Our Ref: SSD 9409987

Subject: Moss Vale Plastics Recycling Facility (SSD 9409987) – Response to Request for Information

Subject: Moss Vale Plastics Recycling Facility (SSD 9409987) – Response to Question on Notice

Figure X

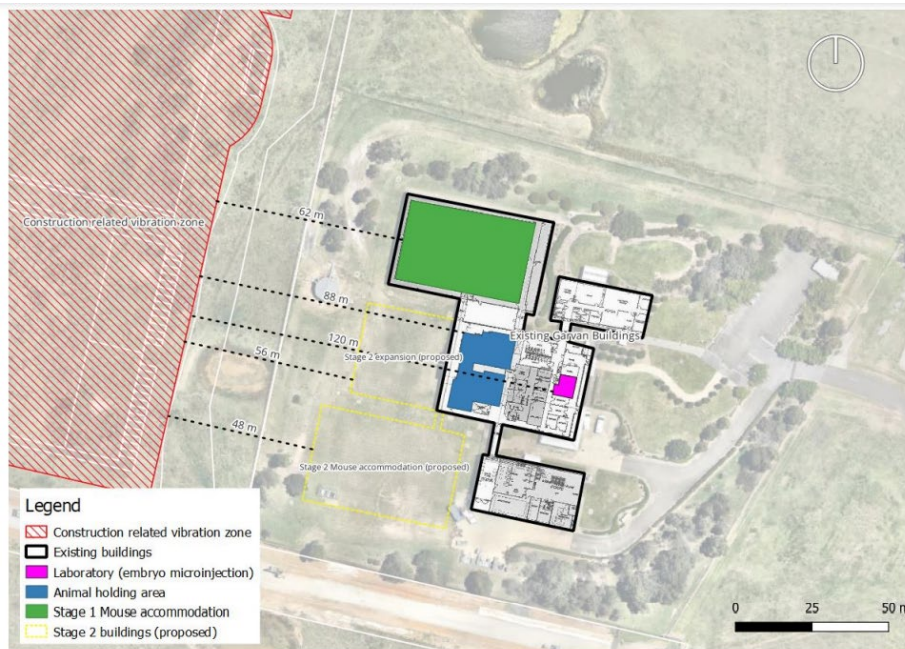
- (c) describe the procedures to:*
 - (i) refine the construction methodology to minimise vibration impacts at vibration sensitive areas identified in Figure X, including, as necessary, the use of a non vibratory ground compaction techniques;*

Condition B54: *The Applicant must prepare a Construction Noise and Vibration Management Plan (CNVMP) for the development to the satisfaction of the Planning Secretary. The CNVMP must form part of the CEMP in accordance with condition C2 and must:*
